FORM APPROVED  
OMB NO. 1004-0135  
Expires: July 31, 2010**SUNDRY NOTICES AND REPORTS ON WELLS**  
*Do not use this form for proposals to drill or to re-enter an abandoned well. Use form 3160-3 (APD) for such proposals.*5. Lease Serial No.  
NMLC028375B

7. If Unit or CA/Agreement, Name and/or No.  
NMNM1031548. Well Name and No.  
OXY ROSCOE FEDERAL 29. API Well No.  
30-015-33660-00-S110. Field and Pool, or Exploratory  
CROW FLATS11. County or Parish, and State  
EDDY COUNTY, NM**SUBMIT IN TRIPLICATE - Other instructions on reverse side.**

OXY USA WTP LP - Proposed  
OXY Roscoe Federal #2  
API No. 30-015-33660

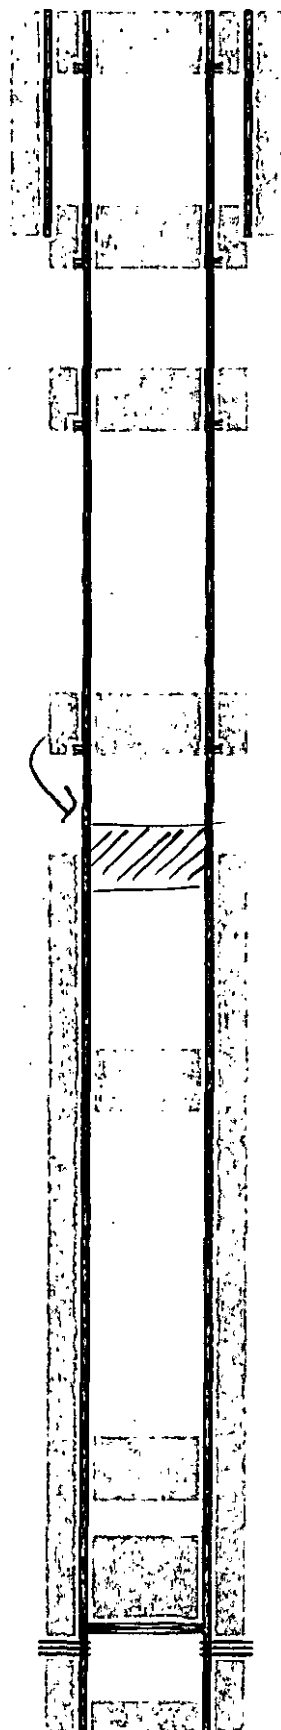
**\*\* BLM REVISED \*\* BLM REVISED \*\* BLM REVISED \*\* BLM REVISED \*\* BLM REVISED \*\***

(High Cave/Karst)

2790-2660

(T. Glorietta @ 2740)

move Plug

25sx @ 4850-4700'

(T. Abo @ 4750)

Perf @ 2350'  
2790
